Hi-Fi Products
Service Bulletin

Model: CDP-C401/500

No. 92

Subject: No Tray Operation

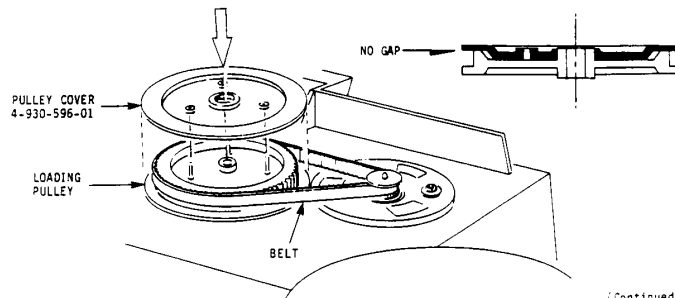
1. Remove bottom panel.

2. Re-install belt.

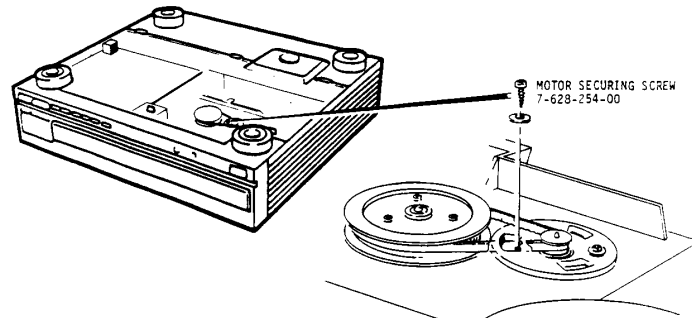
3. Install Pulley Cover on the Loading Pulley.

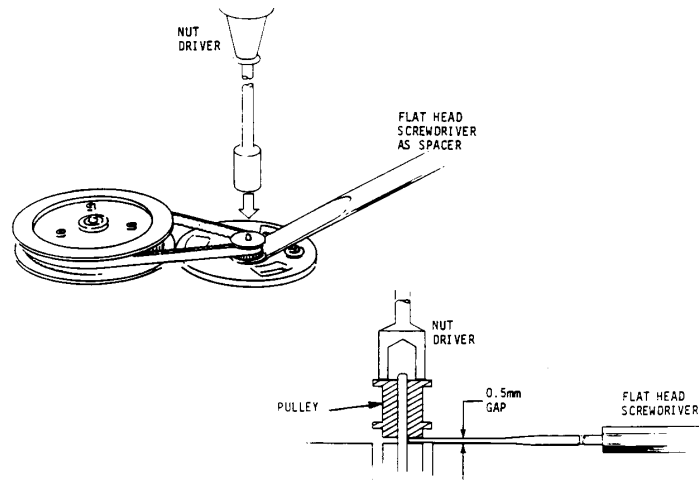
4. Add screw to better secure motor movement as shown.
Part Number of screw is: 7-628-254-00.

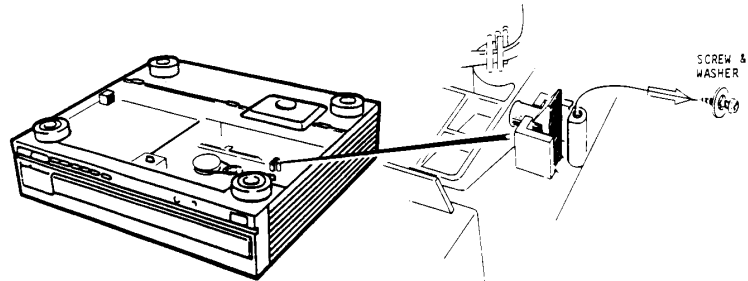
5. Push pulley down into the shaft of the motor using a nut driver. Use a small flat head screwdriver as a spacer between the pulley and the motor.

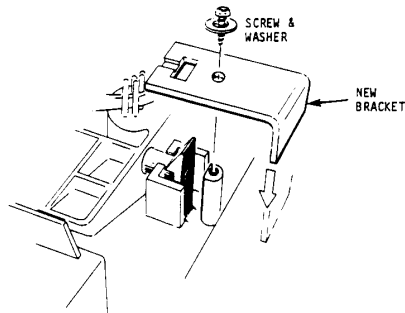
6. Remove the screw and washer, which support the Optical Assembly Bracket.

7. Install the new bracket with the screw and washer that were removed in the previous step.
